# Wisconsin Department of Transportation

**Proposal #02: 1646-08-72**  
**C Westby, N Main Street Project**  
**High Echo Lane to Locust Street**  
**USH 14**  
**Vernon County**

This is Addendum No. 01, which provides for the following:

**ADDENDUM NO. 01**

SHEET 510A

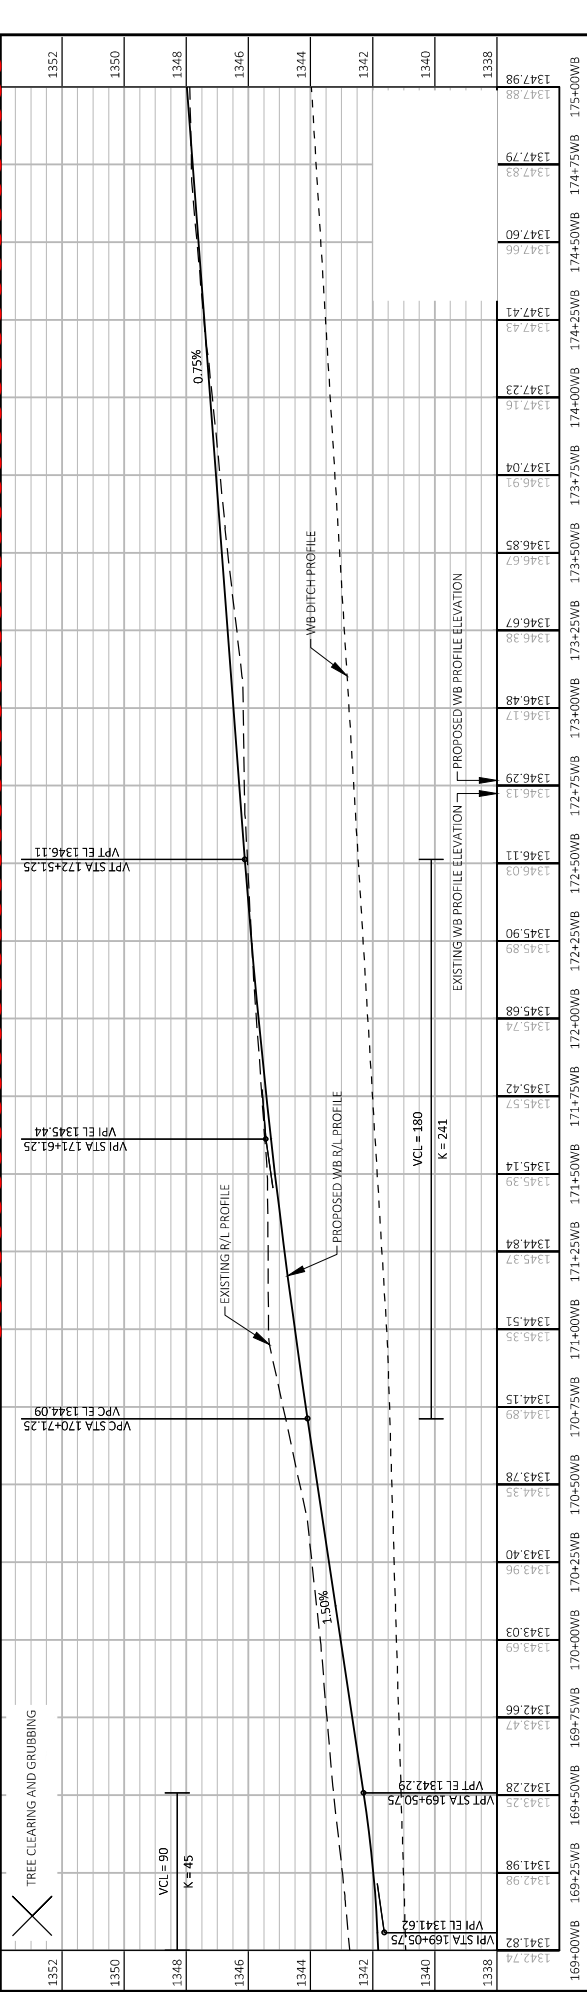
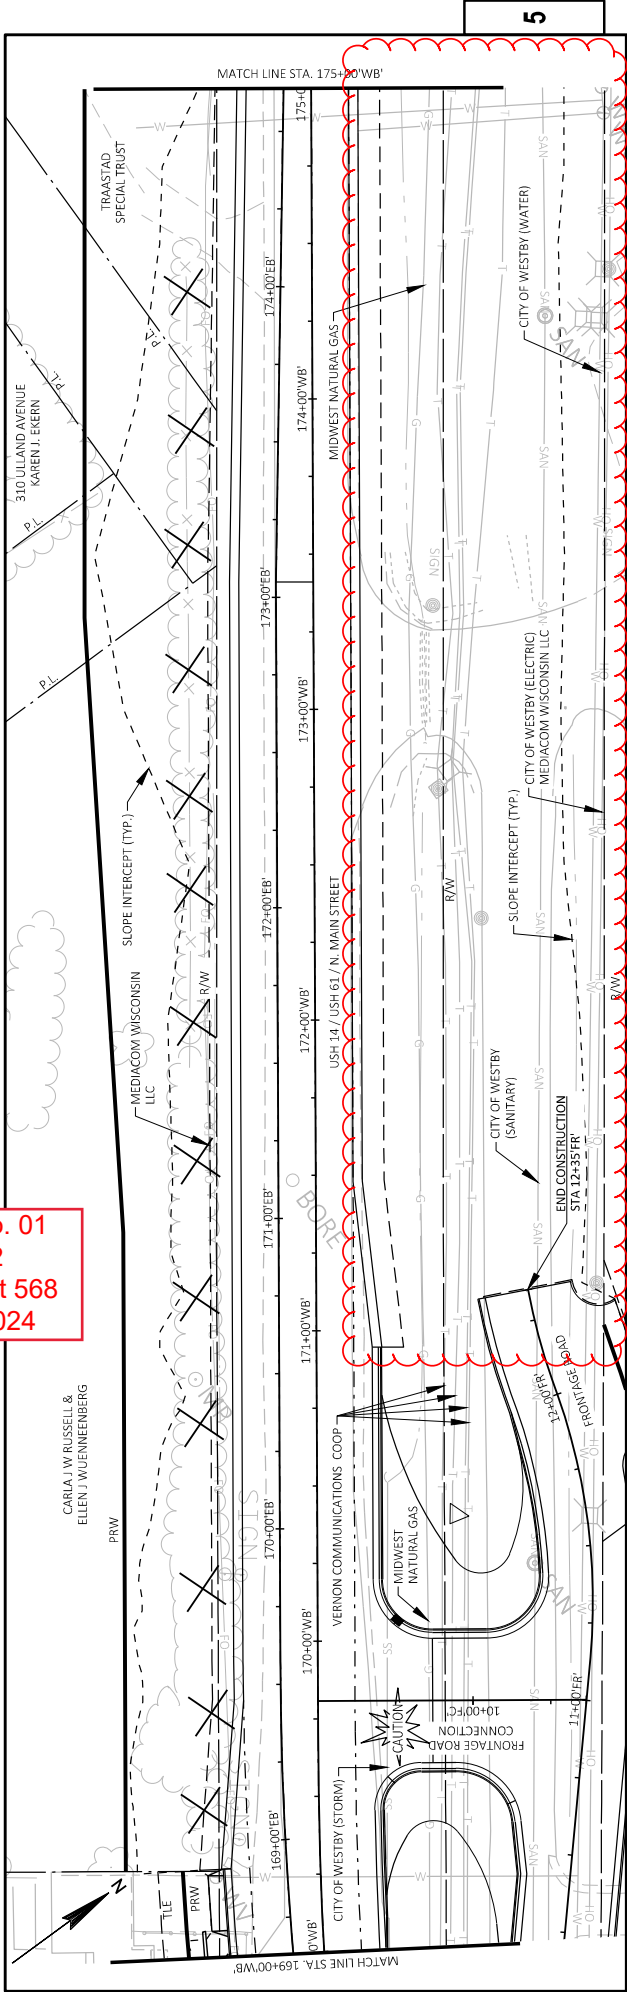
<b>Added Plan Sheets</b>	
Plan Sheet	Plan Sheet Title (brief description of why sheet was added)
510 A	Miscellaneous Quantities (new R/W items)
569 A	Plan and Profile (revised slope intercepts)

Addendum No. 01  
ID 1646-08-72  
Added Sheet 510A  
February 2, 2024

PROJECT NO: 1648-08-72  
 COUNTY: VERNON  
 PLAN AND PROFILE: USH 14 WB  
 SHEET 568

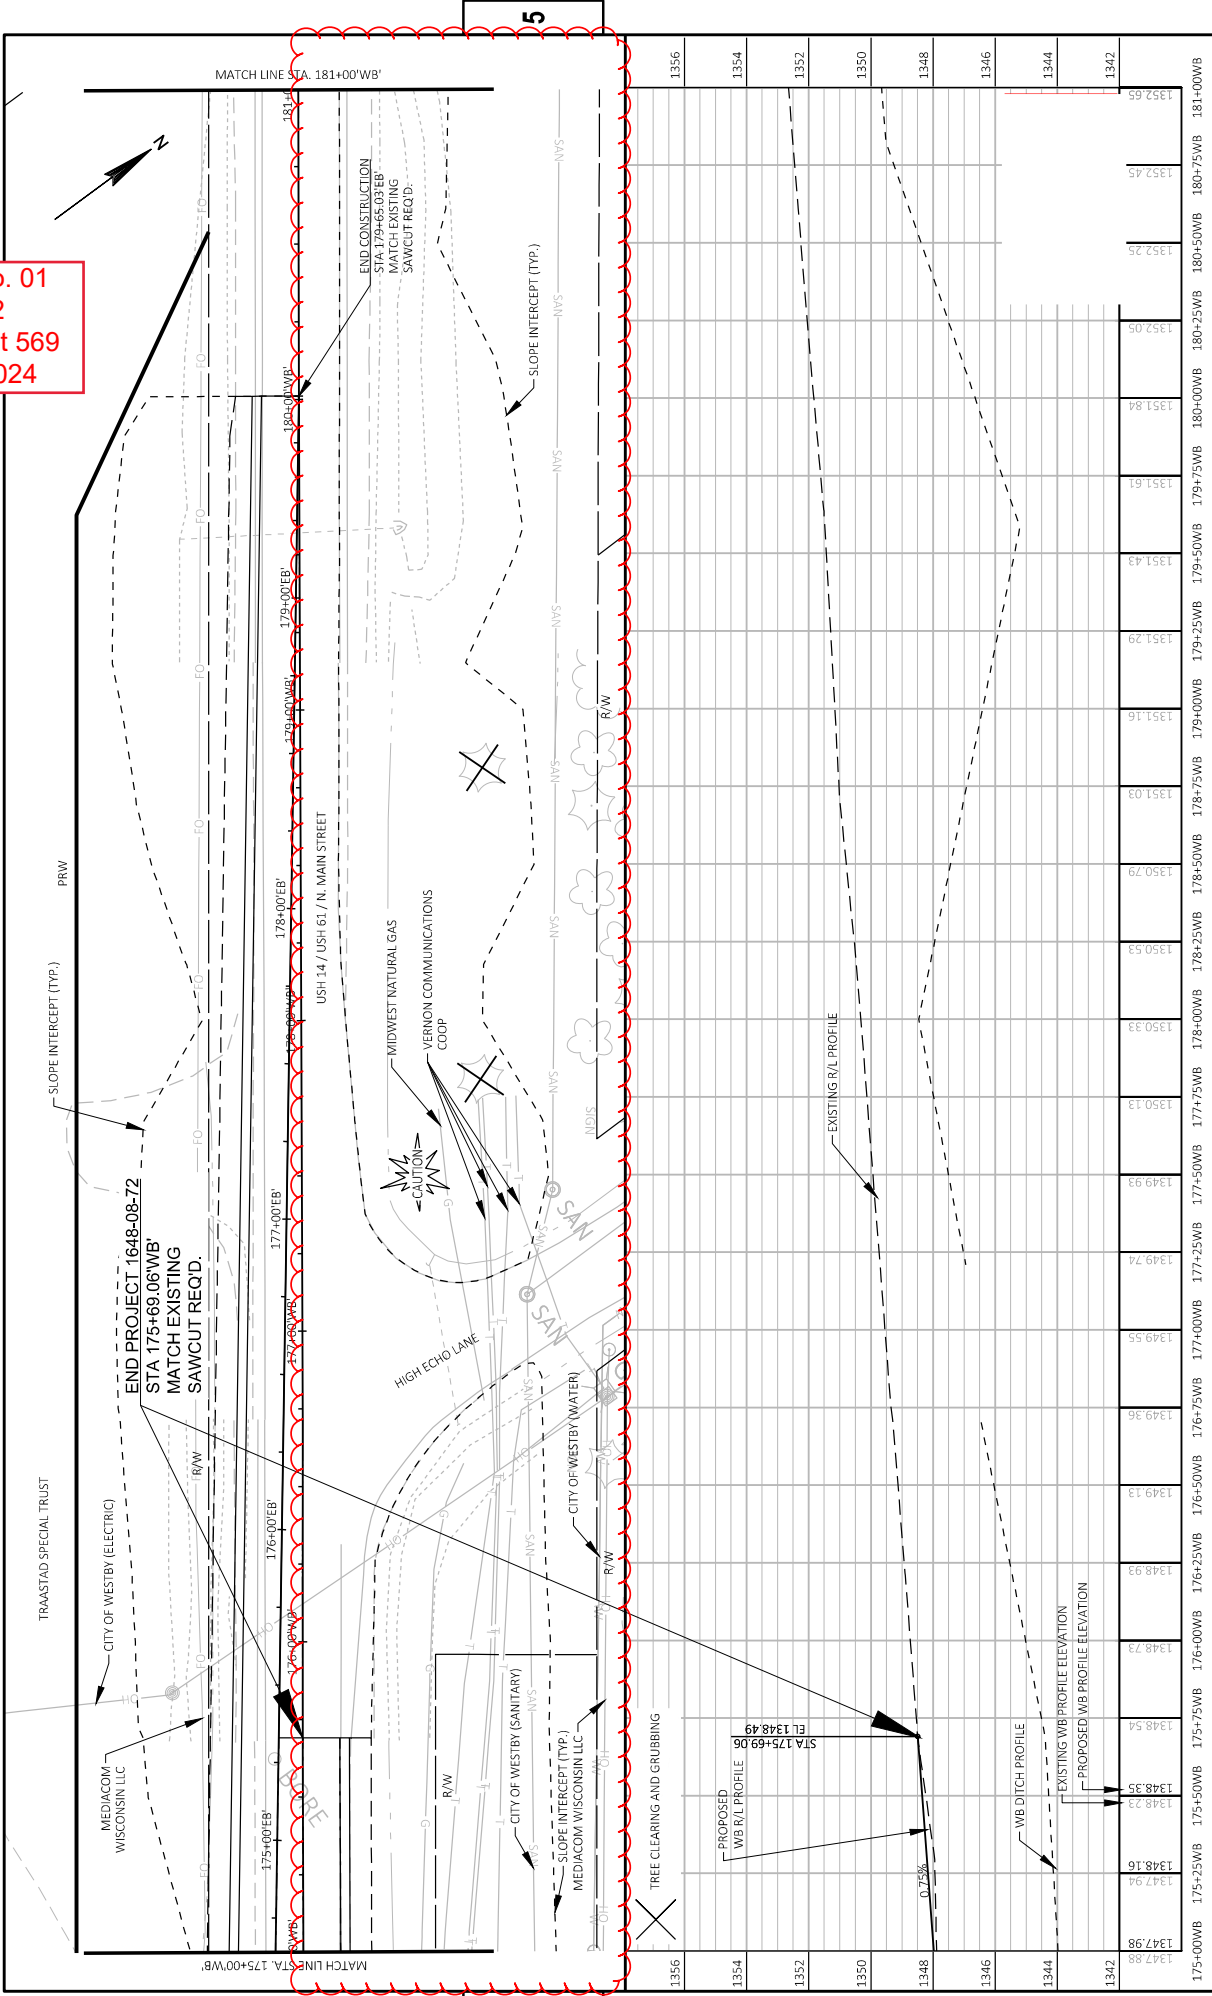
<b>Revised Plan Sheets</b>	
Plan Sheet	Plan Sheet Title (brief description of changes to sheet)
568 – 569	Plan and Profile (revised slope intercepts)
574 – 575	Plan and Profile (revised slope intercepts)

Addendum No. 01  
 ID 1646-08-72  
 Revised Sheet 568  
 February 2, 2024

PROJECT NO: 1648-08-72  
 COUNTY: VERNON  
 HWY: USH 14  
 PLAN AND PROFILE: USH 14 WB  
 PLOT BY: KL ENGINEERING  
 PLOT DATE: 1/31/2024 2:21 PM  
 PLOT SCALE: 1 IN=40 FT  
 SHEET 569  
 E

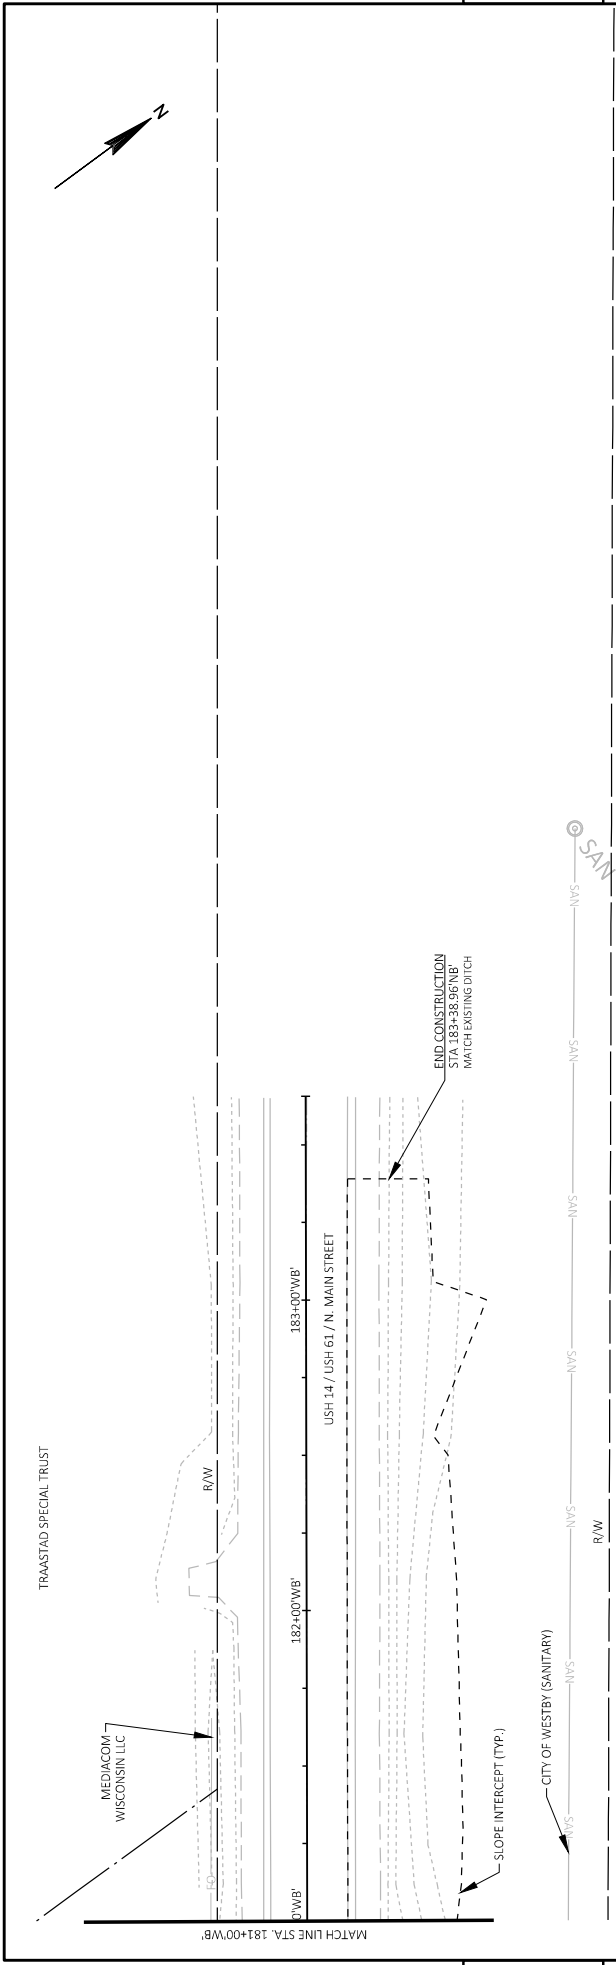
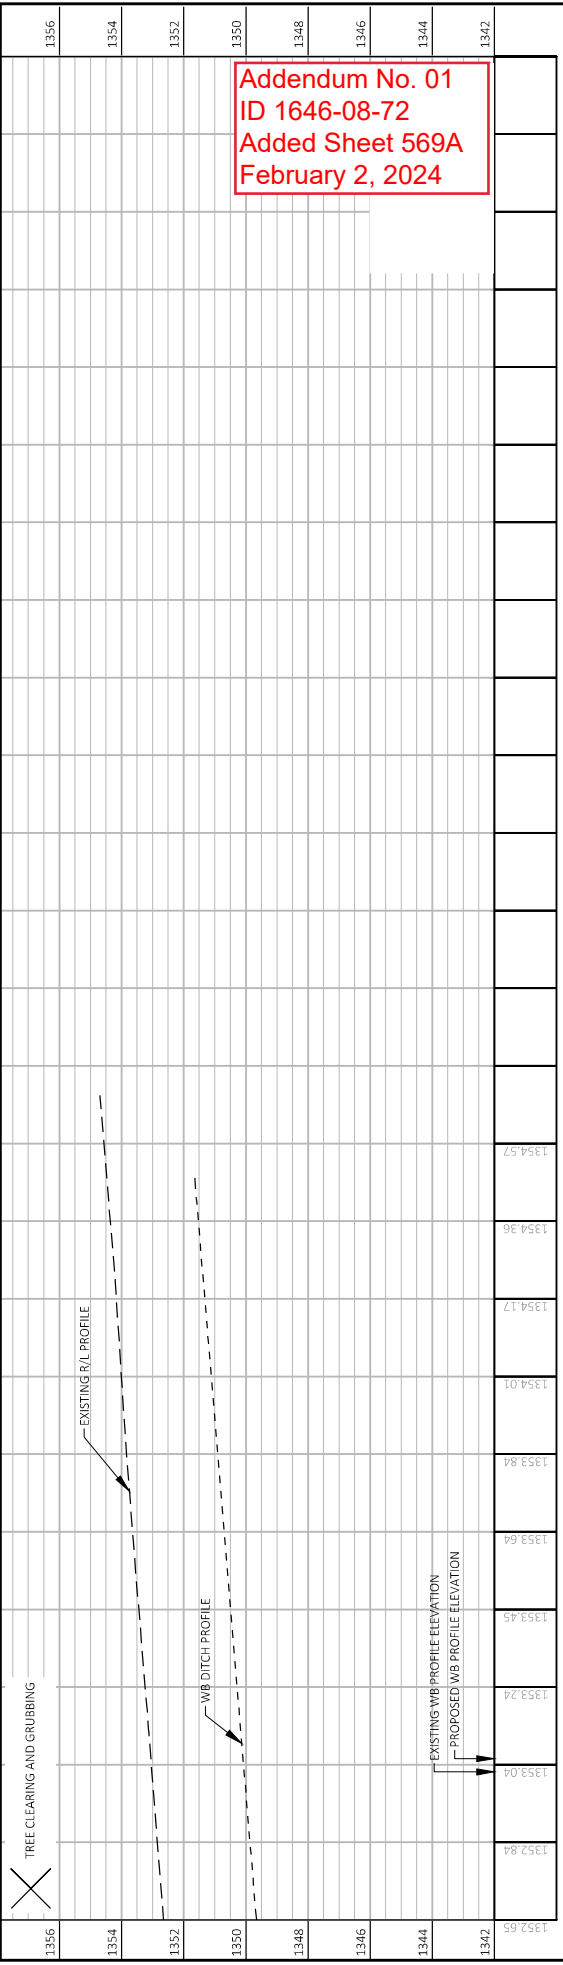
Addendum No. 01  
 ID 1646-08-72  
 Revised Sheet 569  
 February 2, 2024

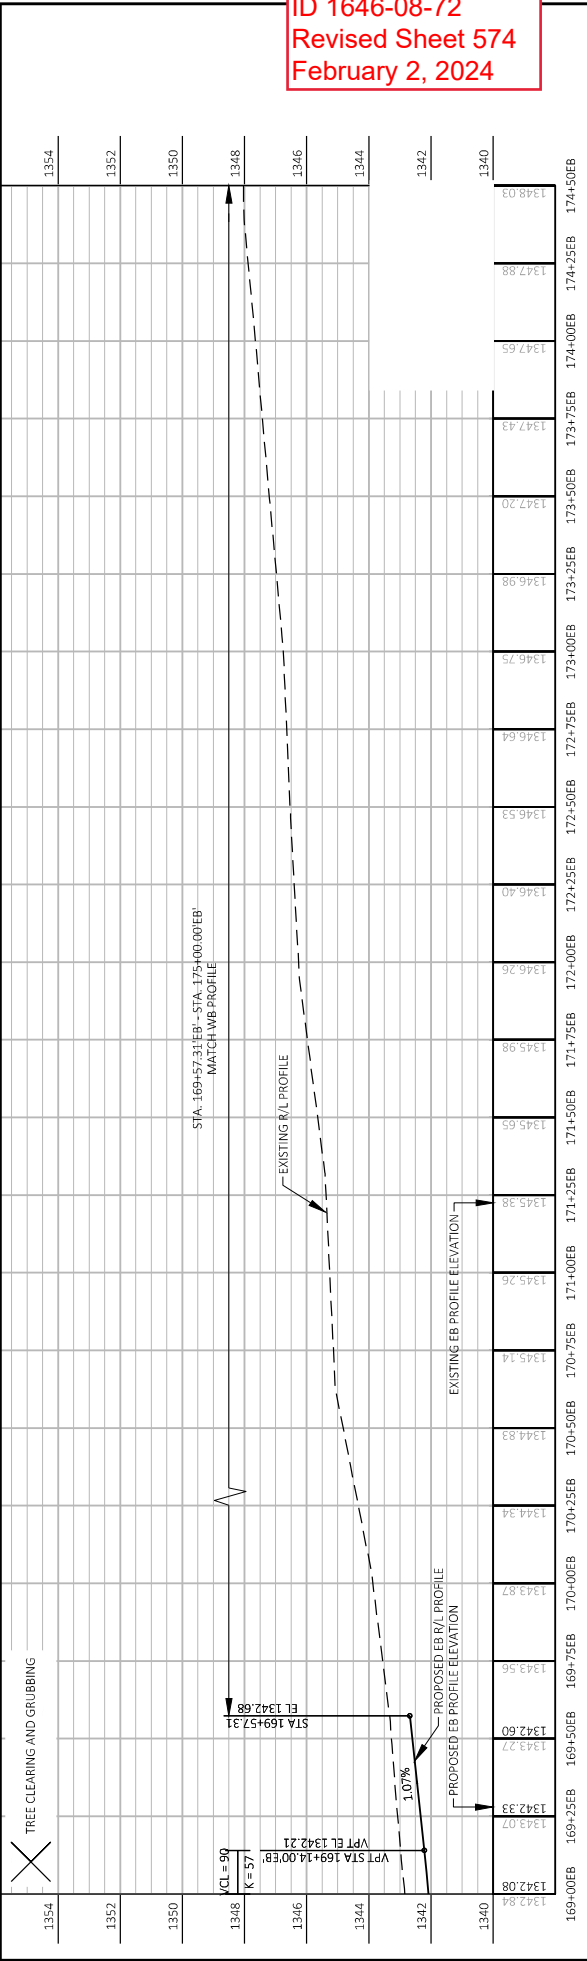
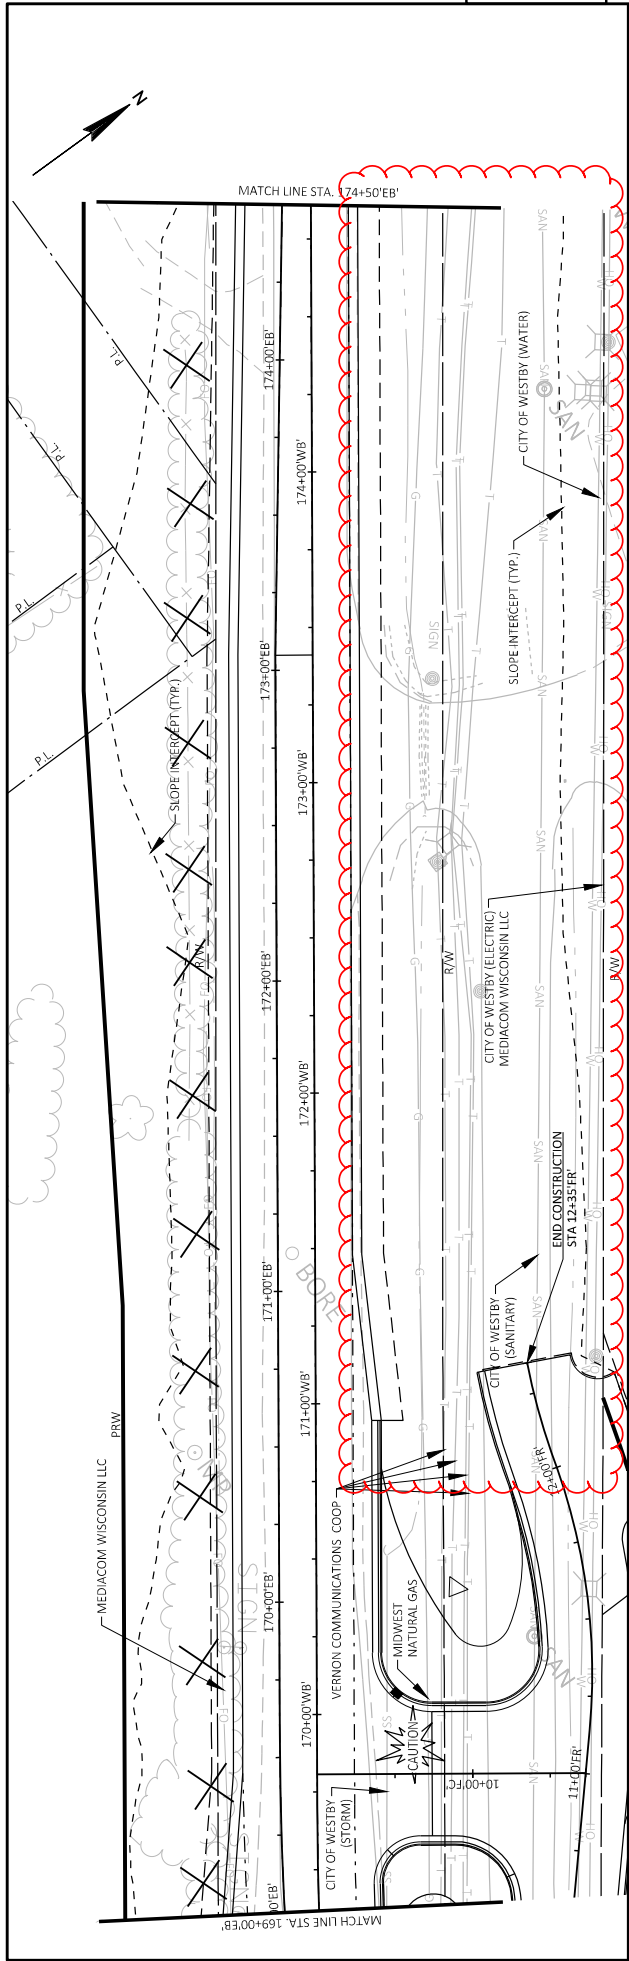
Addendum No. 01  
 ID 1646-08-72  
 Added Sheet 569A  
 February 2, 2024
